Lloyd's Register of Shipping.

Ship's Name "FOLDA"Official No. 145981

Memorandum of alterations reported since ship was surveyed for assignment of Load Lines
in _____

SKETCH SHOWING POSITION OF ESCAPE HATCHES 17/4/39.

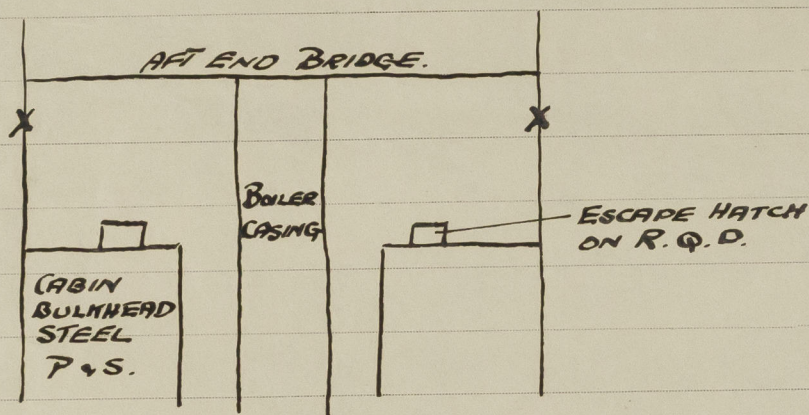
It is noted that the escape hatches to bunkers (P.S.) fitted 17/4/39 in way of Cabin bulkhead in recess passage to ash shoots on R.Q.D., size 23" x 18", have been modified by the construction of trunkways extending through to the wood deck. Closing arrangements have been provided by the fitting of flush bunker scuttles. These were found without chain attachments, but have now been fitted.
